U-603282
8E.100a

Subject: Clinton Power Station Proposed Amendment of
Facility Operating License No. NPF-62 (LA-98-013)

Revision of the RPS Electric Power Monitoring Assembly Overvoltage and Undervoltage Allowable Values

NSPS SOLENOID POWER
(RPS SOLENOID POWER)

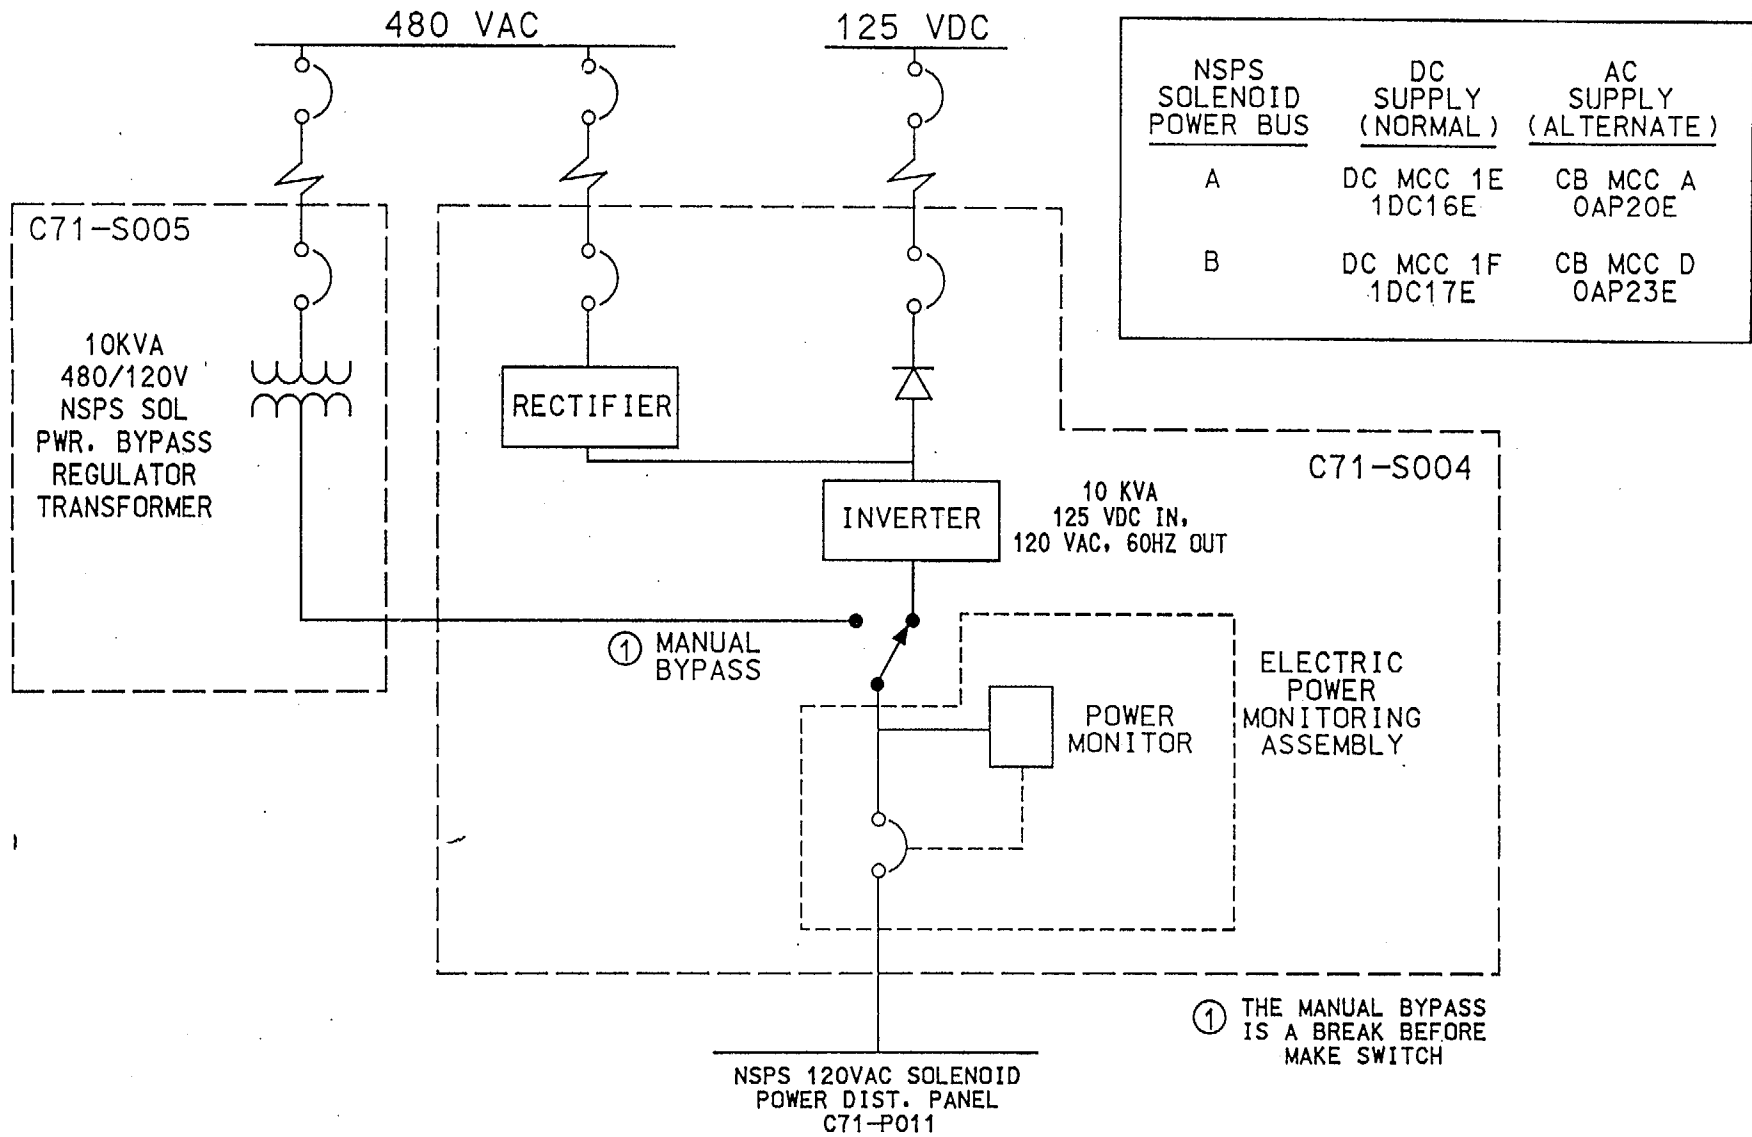
The non-divisional portion provides power to the RPS solenoid buses and is configured similar to the divisional portion. The RPS solenoid bus power supplies also have a normal and alternate lineup. The normal (preferred) lineup is via the UPS and consists of a Class 1E, DC-to-AC power inverter fed from a non-Class 1E battery and associated 480-to-120 VAC charger, or non-Class 1E source. The alternate supply is from a Class 1E-qualified regulating transformer fed from the same non-Class 1E bus as the battery charger. The inverter output includes a Class 1E-qualified power monitor system which, independently of the inverter, trips the RPS bus supply output breaker upon sensing overvoltage, undervoltage, overfrequency, or an underfrequency condition during either normal operation from the inverter or bypass operation from the alternate source. The power monitoring circuit and breaker combination is typically referred to as an electric power monitoring assembly. [See attached figure.]

During analysis of a required replacement of the Reactor Protection System (RPS) Electric Power Monitoring Assembly circuits, a potential discrepancy (Condition Report (CR) 1-98-12-202, dated December 17, 1998) was identified regarding the Electric Power Monitoring Assembly voltage setpoints provided by General Electric in 1986. A review of the overvoltage and undervoltage setpoints revealed that the setpoints, as specified in the TS and calculation may not have been conservative. After discovery of this condition, a new calculation was prepared to validate the original Electric Power Monitoring Assembly voltage setpoints. This calculation utilized the same original data and methodology defined in GE Design Specification 22A3153 and added sufficient margin to address short-term repeatability, long-term reliability with instrument drift and inaccuracies. The new calculation confirmed that the Electric Power Monitoring Assembly voltage setpoints were

The proposed change revises the Allowable Values for RPS Electric Power Monitoring Assembly overvoltage and undervoltage trip functions. Since these values are specified in Surveillance Requirement (SR) 3.3.8.2.2 of the CPS Technical Specifications, SR 3.3.8.2.2 would be revised to reflect the new values as follows:

Proposed SR 3.3.8.2.2 Allowable Values

- a. Overvoltage
Bus A ≤ 127.3 V
Bus B ≤ 126.7 V
- b. Undervoltage
Bus A ≥ 115.0 V
Bus B ≥ 114.7 V
